RC3600 , 6000 , 7000 OPERATING GUIDES

FIELD CHANGE ORDER

EQUIPMENT AFFECTED
RC3600/6000/7000/8000
POW728
Master Power Supply Electronics

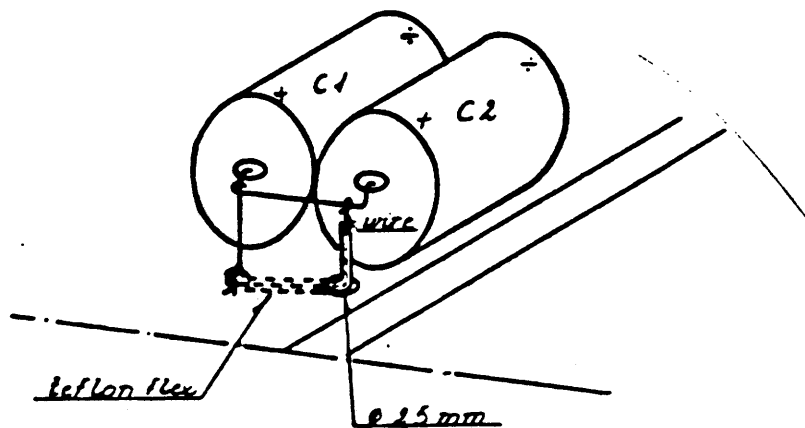
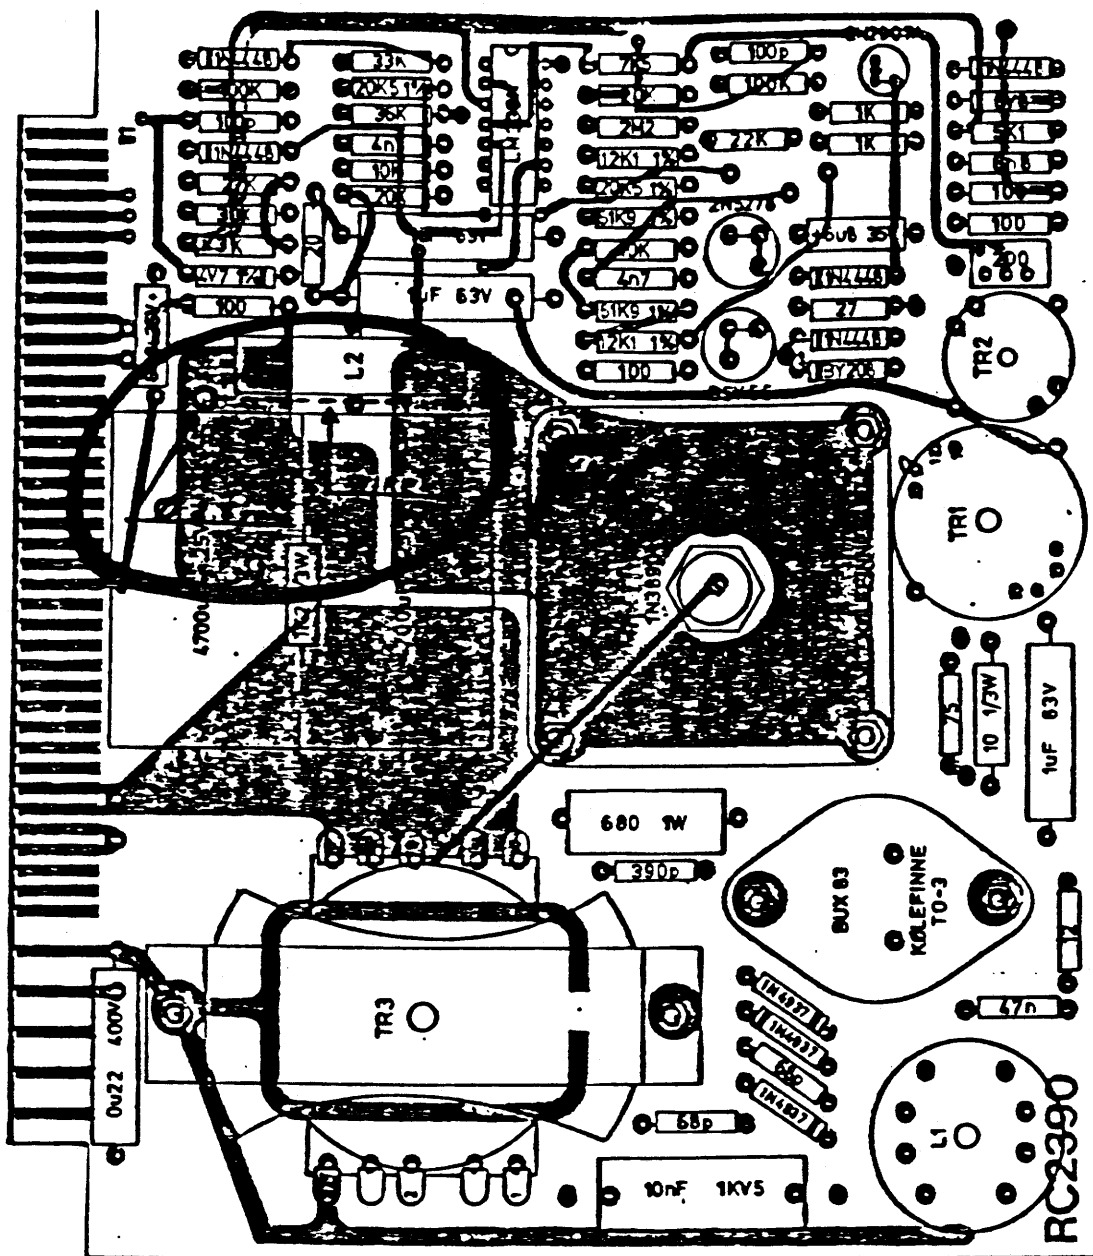
The RMS value of the ripple current to which the capacitor C 1 is exposed, exceeds the absolute maximum rating. As a result, the capacitor is overheated and the life-time is decreased.

1. Unsolder the positive terminal lead of the capacitor C 2 from the print.
2. Increase the diameter of the hole using a 2.5 mm drill.
3. Mount the capacitor C 2 according to the illustration, see page 2.
4. Code the FCO-Label

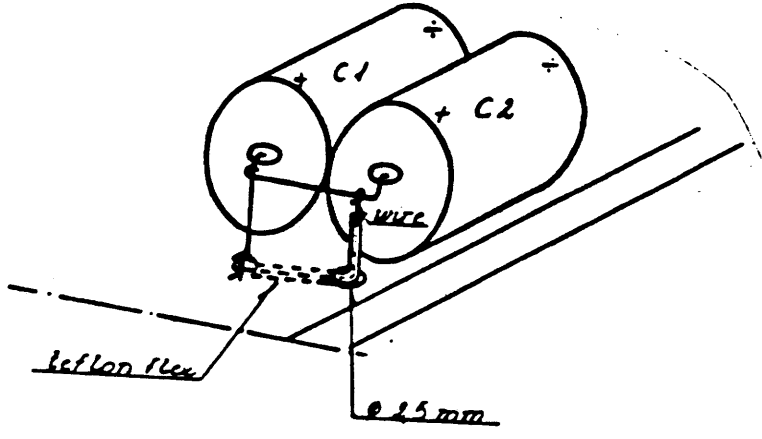
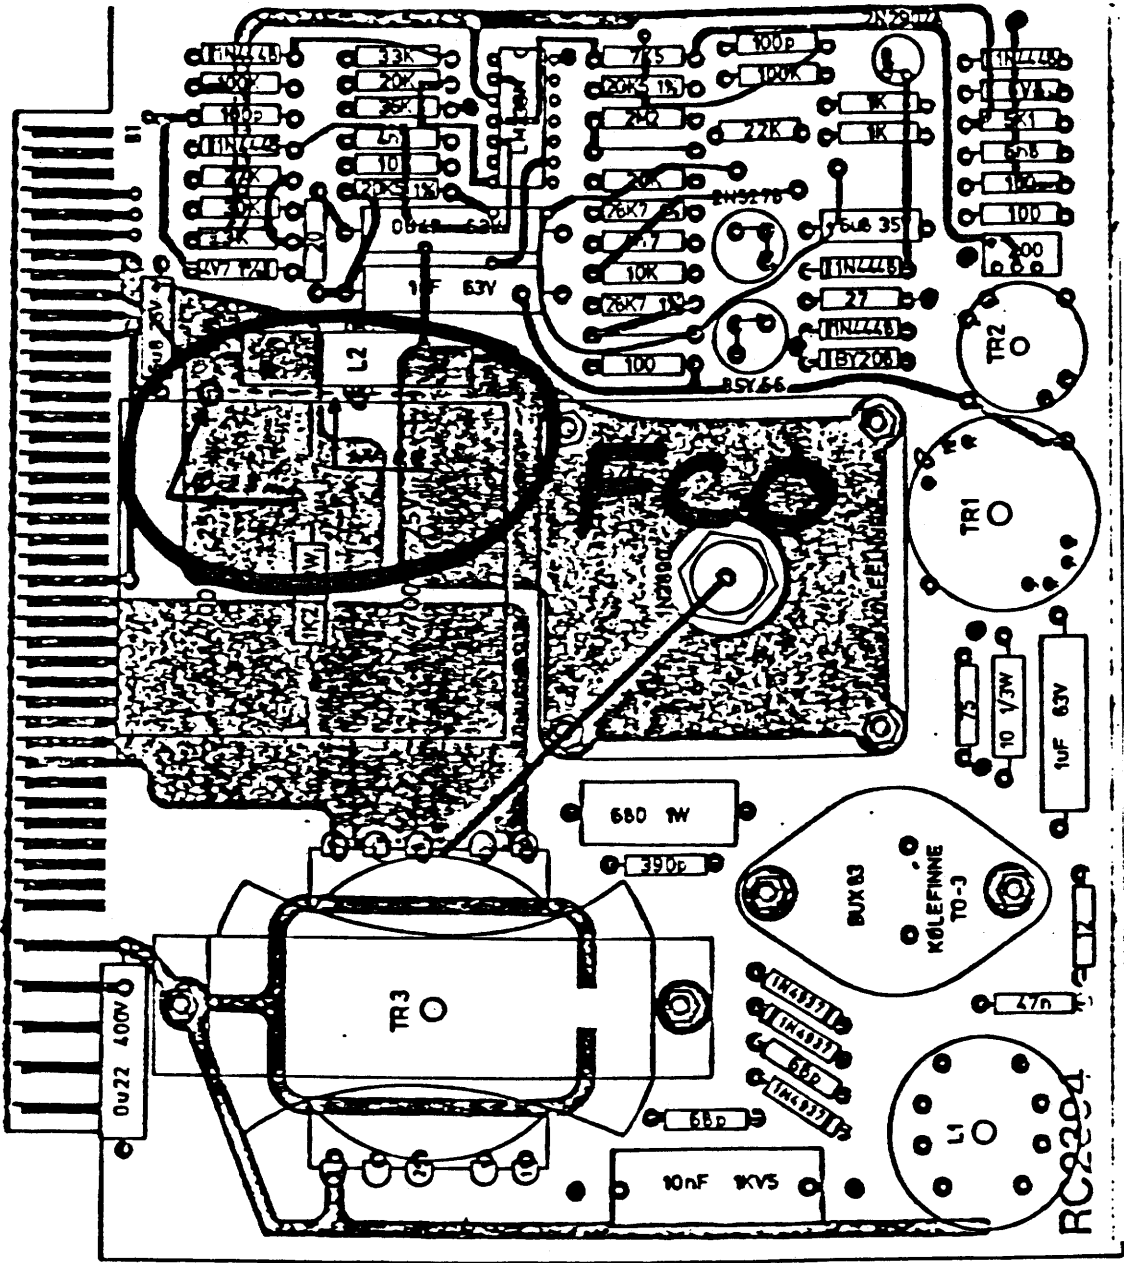
The RMS value of the ripple current to which the capacitor C 1 is exposed, exceeds the absolute maximum rating. As a result, the capacitor is overheated and the life-time is decreased.

1. Unsolder the positive terminal lead of the capacitor C 2 from the print.
2. Increase the diameter of the hole using a 2.5 mm drill.
3. Mount the capacitor C 2 according to the illustration, see page 2.
4. Code the FCO-Label

PAPER TAPE READER CONTROLLER

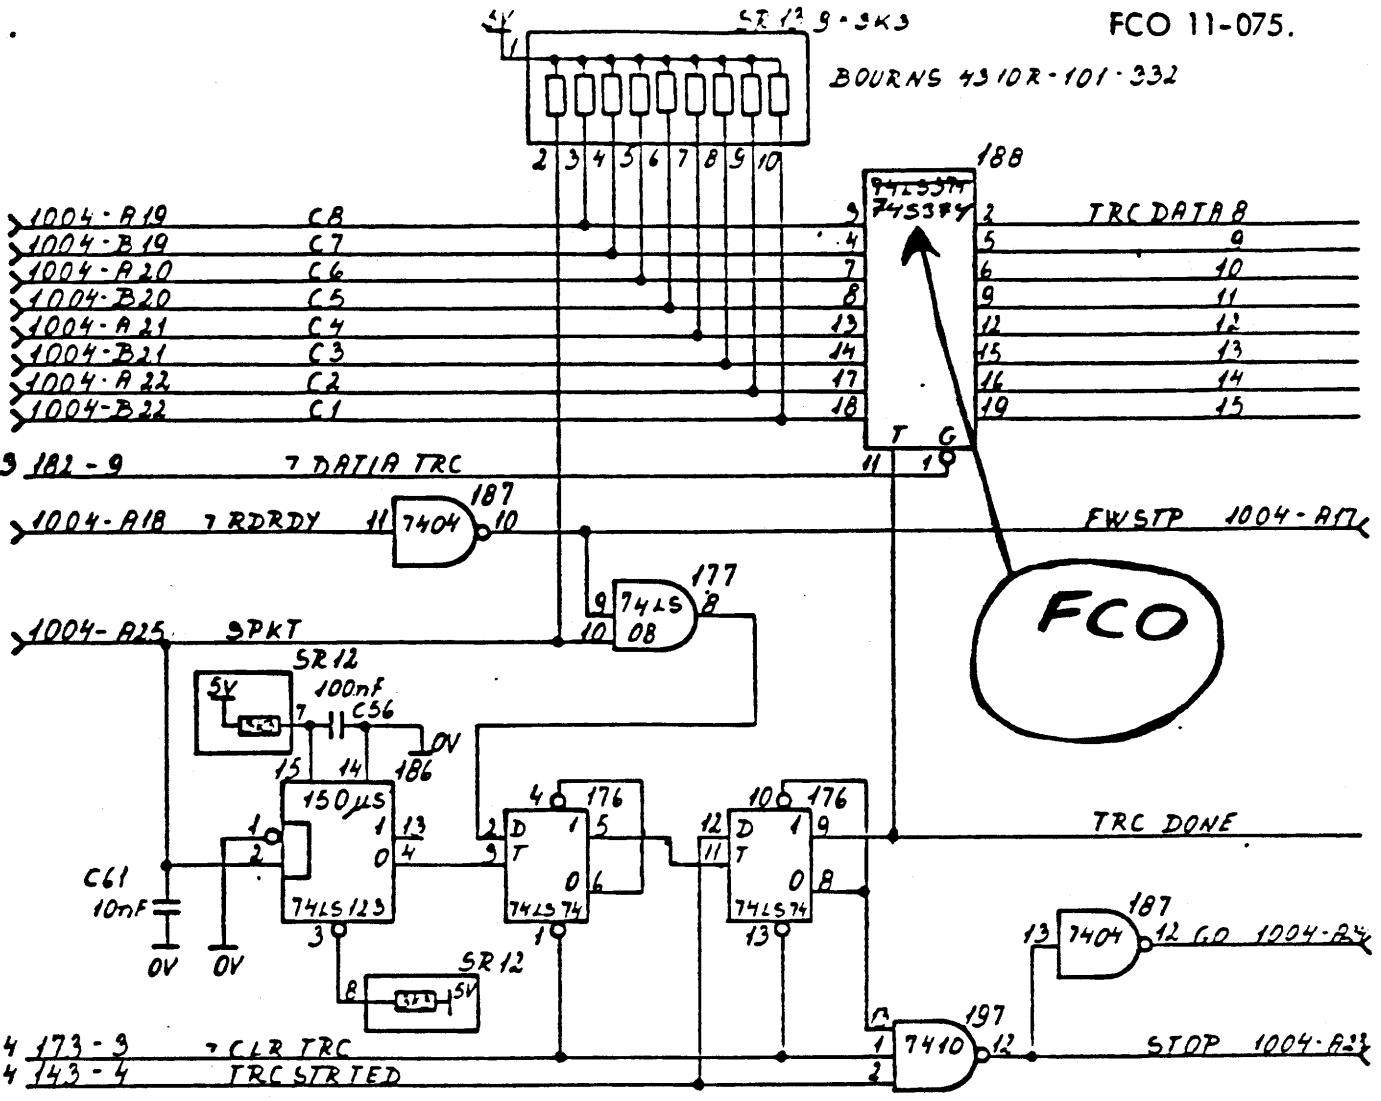
The paper tape reader controller on MEM 720 is not working properly. Sometime the controller converts "ones" to "zeroes".

- Change the IC in pos. 188 from an SN74LS374 to a SN74S374.
- Code the FCO-label: 11-075.

POW 729 * 5V POWER MODULE
CONTROL SECTION
CIRCUIT DIAGRAM

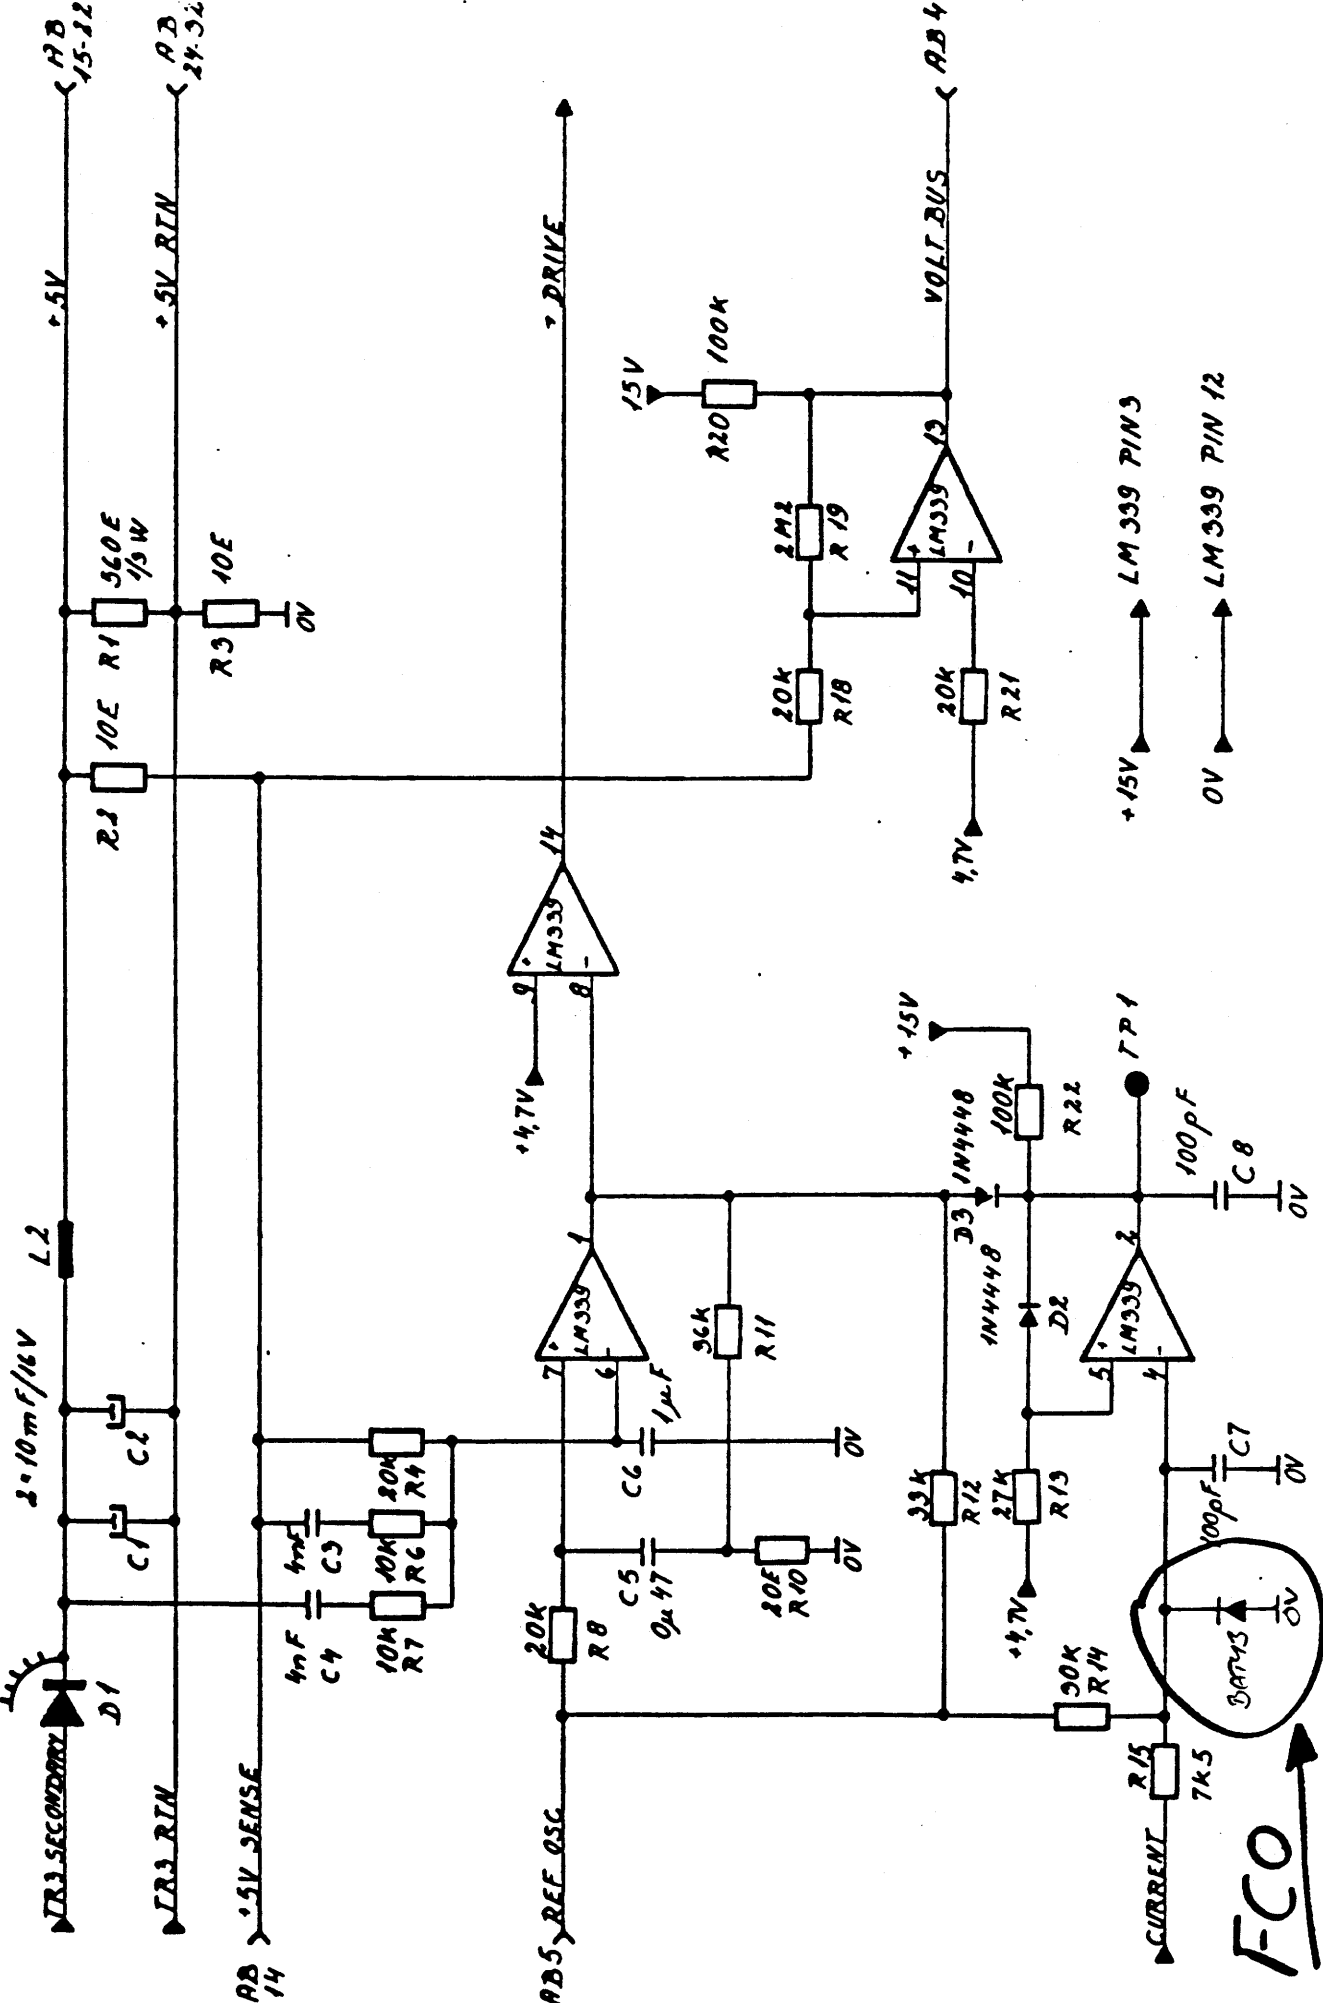
The RMS value of the ripple current to which the capacitor C 1 is exposed, exceeds the absolute maximum rating. As a result, the capacitor is overheated and the life-time is decreased.

1. Unsolder the positive terminal lead of the capacitor C 2 from the print.
2. Increase the diameter of the hole using a 2.5 mm drill.
3. Mount the capacitor C 2 according to the illustration, see page 2.
4. Code the FCO-Label

FCO 11-096

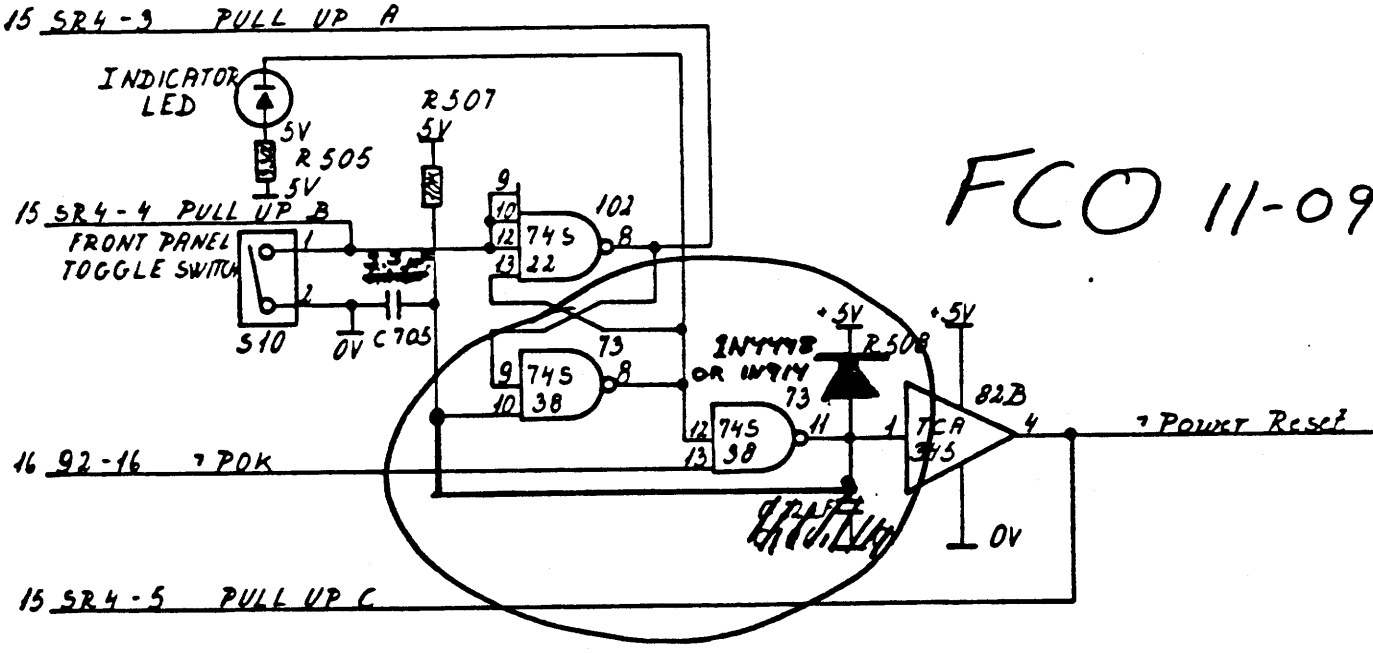
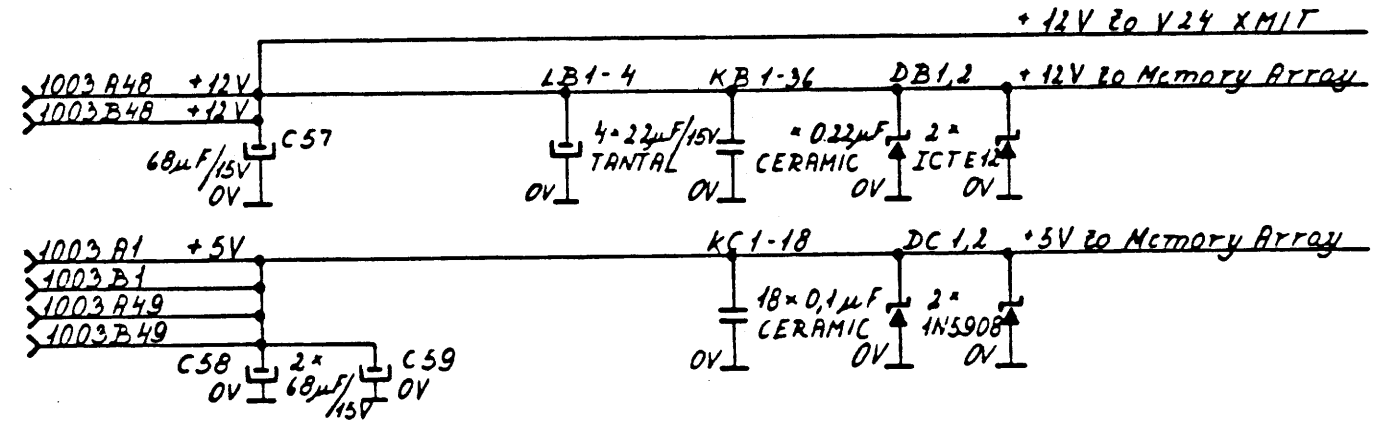
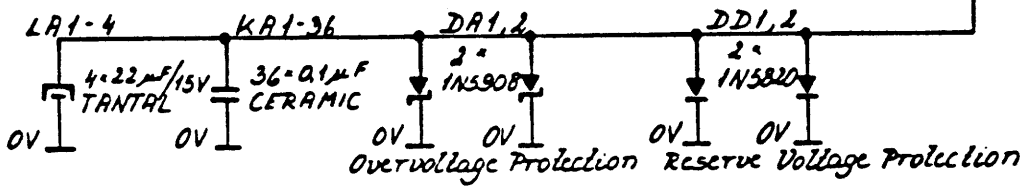
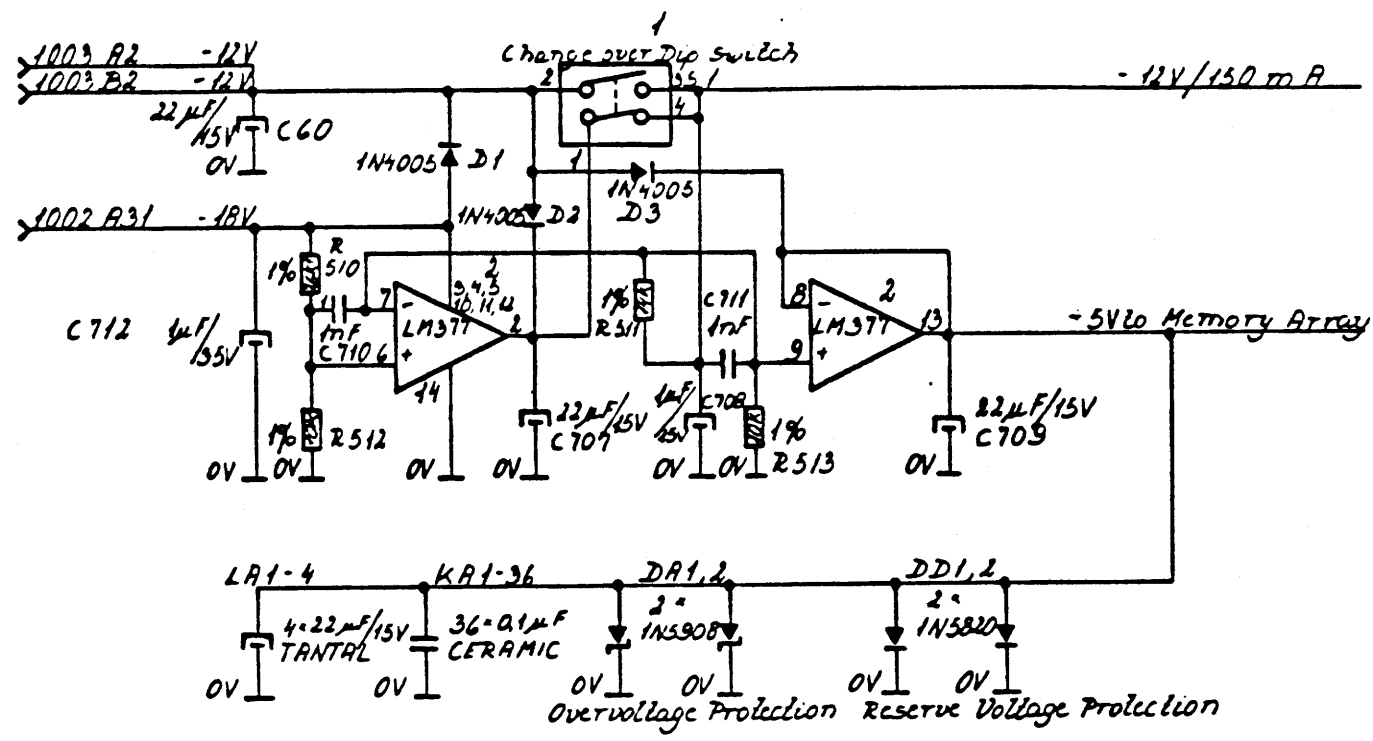
The "Mem. Init. Inhibit" flip-flop (and indicator) is sometimes set during the power-up condition. As a result the memory control logic is not properly reset and a dead-lock situation can be experienced.

1. Remove resistor R508 and capacitor C706.
2. Mount the diode IN4448 or IN914 instead of R508 (Not necessary if diode is already mounted in parallel with R507).
3. Add wire according to the assembly drawing on page 2.
4. Code the FCO label 11-096.
